## Minor works REF addendum memo

[REDACTED]	[REDACTED]
[REDACTED]	[REDACTED]
[REDACTED]	[REDACTED]
[REDACTED]	[REDACTED]
[REDACTED]	[REDACTED]
[REDACTED]	[REDACTED]
<b>Priority</b>	ROUTINE
<b>Date</b>	19 December 2023
<b>Subject</b>	Minor works review of environmental factors addendum memo for Pennant Hills Road and North Rocks Road, Carlingford Intersection Upgrade Review of environmental factors

Modification to the Pennant Hills Road and North Rocks Road, Carlingford Intersection Upgrade Review of environmental factors

Figure 1. Determined project scope as assessed in project REF (April 2018) and one previous addendum REF (May 2021)

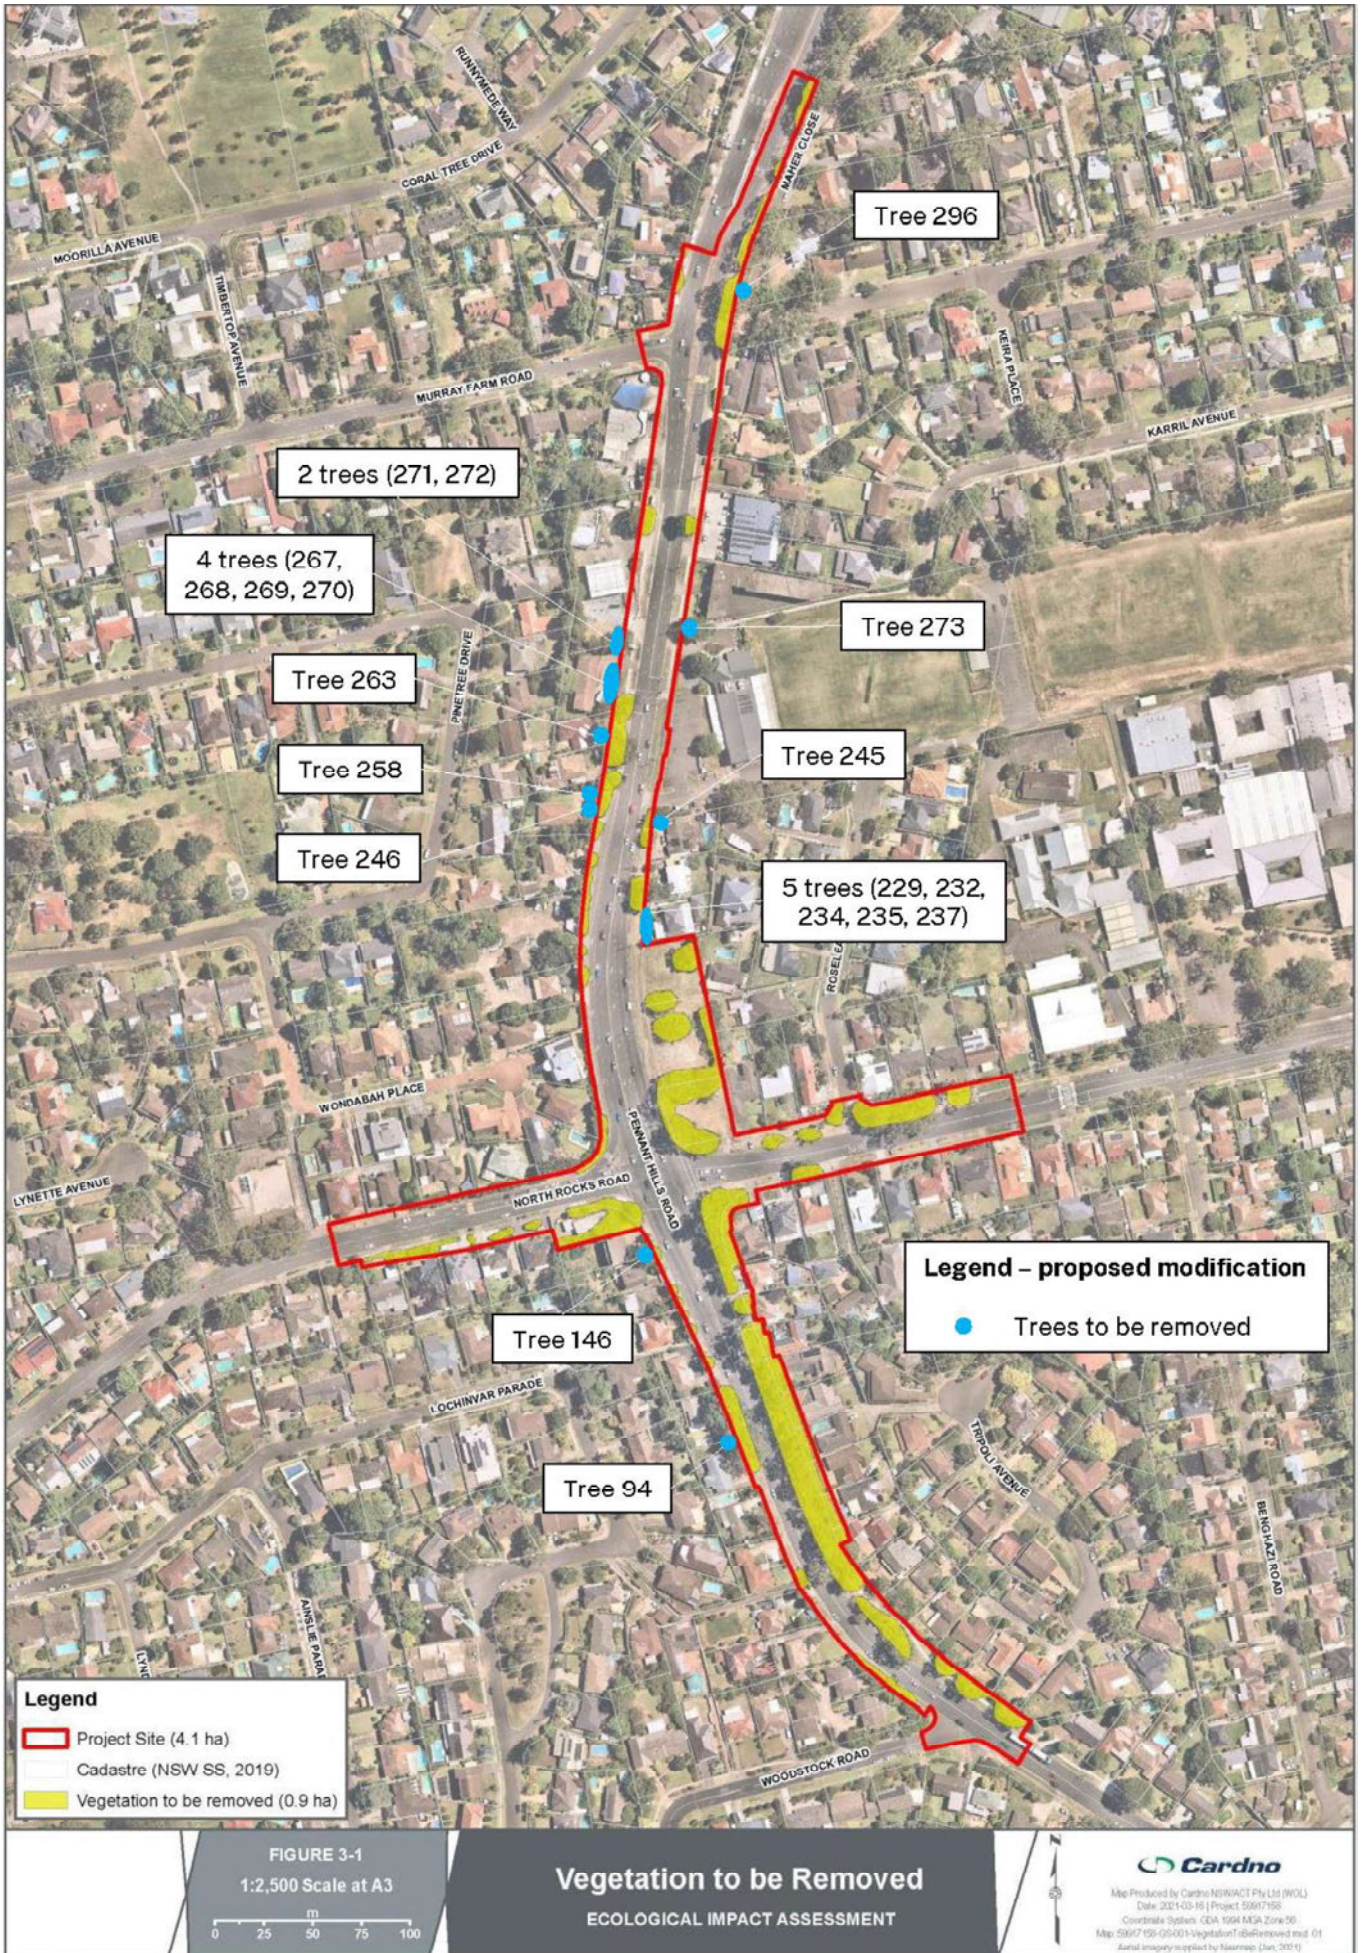
The determined project scope is shown in Figure 1. An overview of the proposed modification is shown in Figure 2 and Figure 3.

Figure 2 Proposed modification overview – trees to be removed

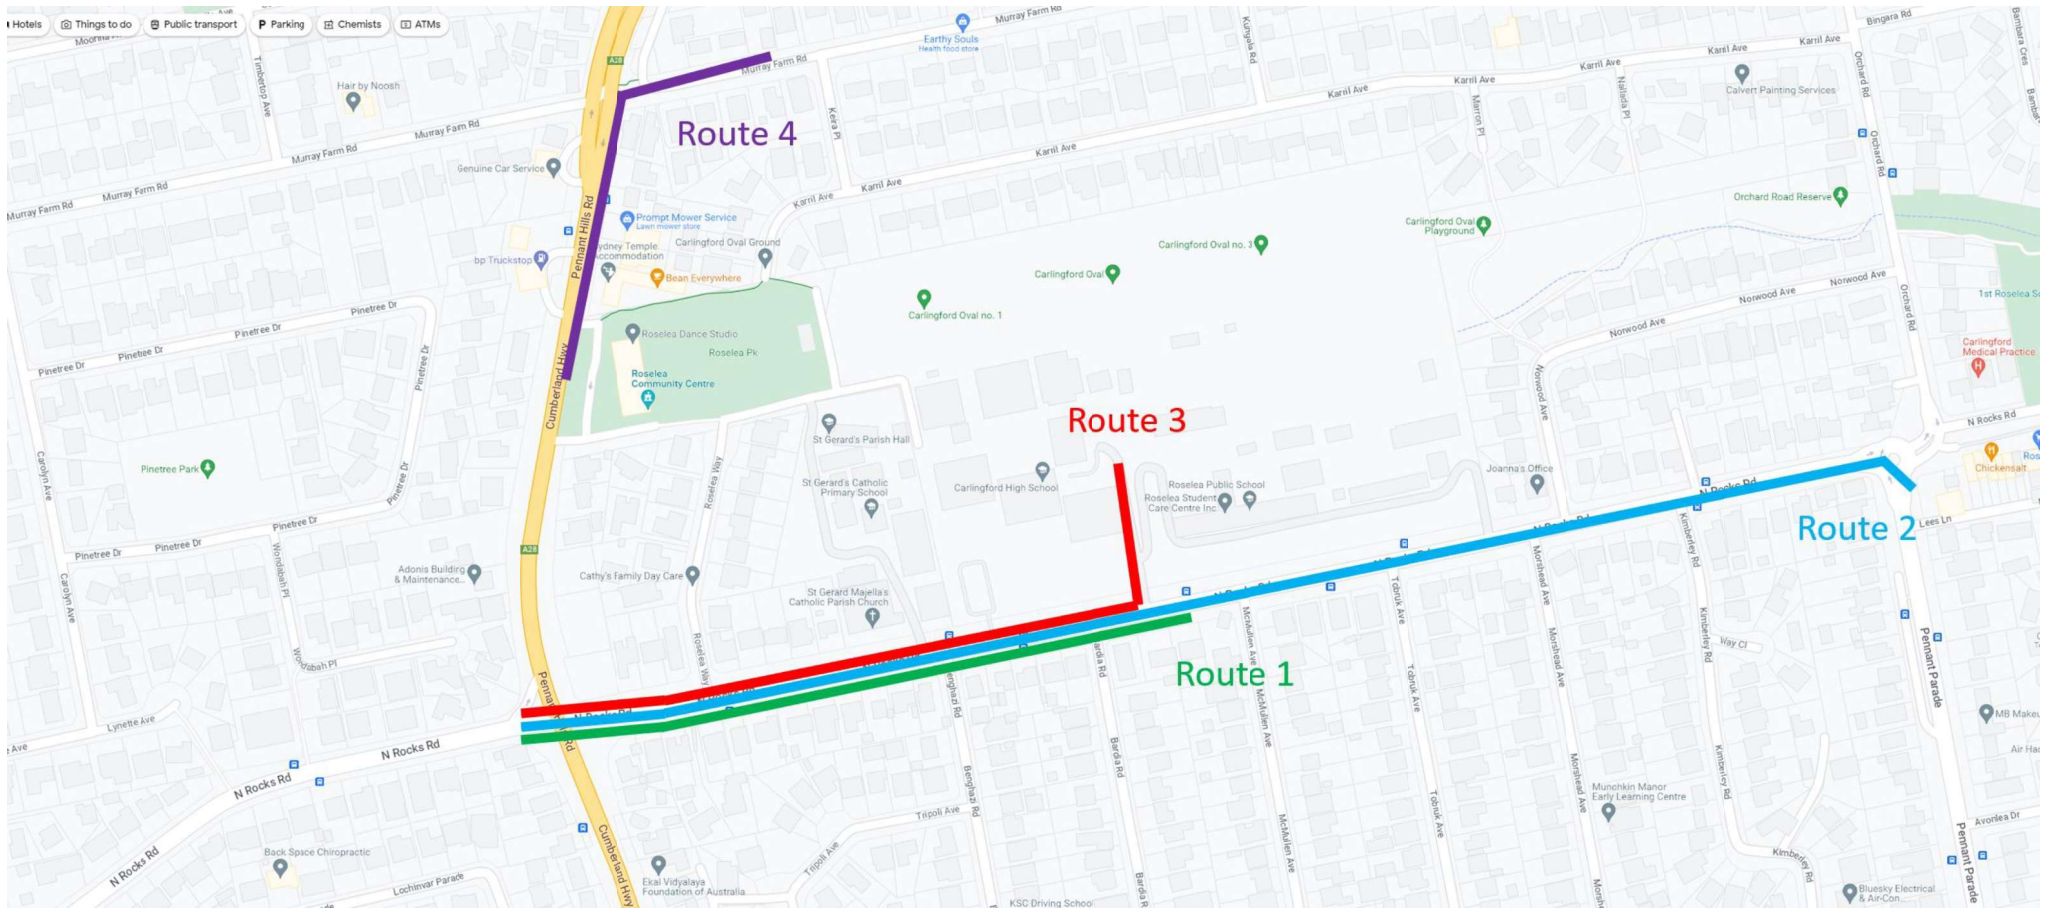
- Removal of 19 additional trees (ID 94, 146, 229, 232, 234, 235, 237, 245, 246, 258, 263, 267, 268, 269, 270, 271, 272, 273 and 296)
- Hauling of Telstra optical fibre cables along four existing cable routes. The works include cabling crews installing draw ropes and hauling through new cables. If the routes are blocked, then localised civil works (excavation and backfill) would be required in order to clear the blockage and allow the cabling to be undertaken. The four routes are as follows:
